ITS CORPORATION

THIS PRINT IS THE PROPERTY OF ITS CORP. IT SHALL NOT BE COPIED WITHOUT PERMISSION.		TITLE 91-00-00-50AJ-61 CHANNEL OSC. BD. DUAL OVEN (1145-1201)			
REV	ECN	DATE	APV		
DWN	RLS	5/9/90		DWG. NO.	REV
CHK	JM	7/30/90		1145-3201	9
REL	JCM	8/1/90		B SCALE---	SHEET 1 OF 1

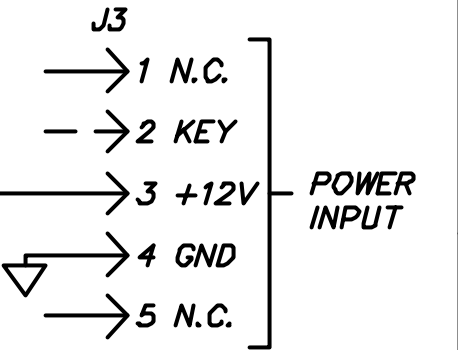
DELETED C15 & C12 CHANGED R4 TO 12K, R6 TO 13K. ADDED C26. (MM)

9	7868	8/11/95	
CHANGED C11 3~15pF TO C11 9~35pF AND ALSO CHANGED C12 FROM 20pF TO 10pF. (RFB)			
8	7627	10/14/94	RE
ADDED NOTE #4. CHGD C7 FROM 3pF TO 5pF. (PJK)			
7	7534	7/1/94	RE
L1 WAS .47uH COIL SL			
6	3774	2/22/93	CAR
ADDED C26, 300pF. R4 AND R6 WERE 24K. SJM			
5	7224	1/20/93	RE
U2 WAS MC78L08C. RLS			
4	3453	2/4/92	WB
C4 WAS C15 (DUP.). RLS			
3	3409	11/18/91	RE
R9 WAS 10K. C2 WAS 25V. (RFB)			
2	3237	7/23/91	JCM
C25 WAS C24 (RFB)			
1	2849	10/29/90	JCM
